BUILDING CODE OF AUSTRALIA REPORT FOR ACO POLYCRETE FACILITY

134 -140 OLD BATHURST ROAD, EMU PLAINS

Report Ref: 19-213566_ACO_R01

Date: 16 August 2019

Figure 6 Building and Structure Clearance Heights

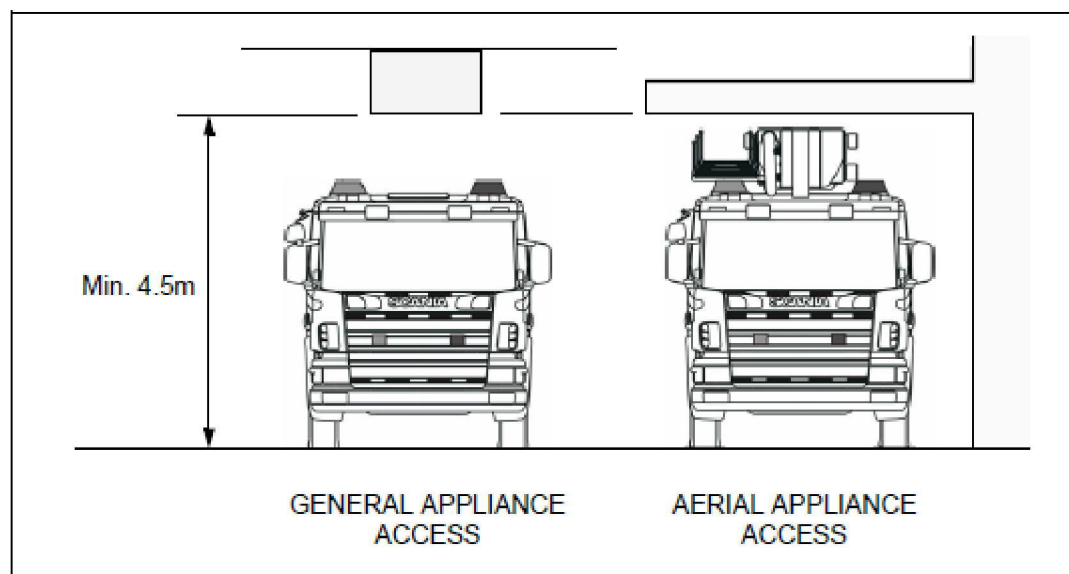
However perimeter access for emergency vehicles is only available on 3 of 4 sides contrary to Clause C2.4(b).

The east side vehicle path passes under a sprinkler protected awning with a clearance of 4.5m.

An extract of the NSW Fire Brigades Guidelines for Emergency Vehicle Access is below and states that a 4.5m clearance height is required throughout the path. Whilst the subject building awning is not strictly a gateway, or overhanging structure, the Fire Brigade could still complete a full lap of the building.
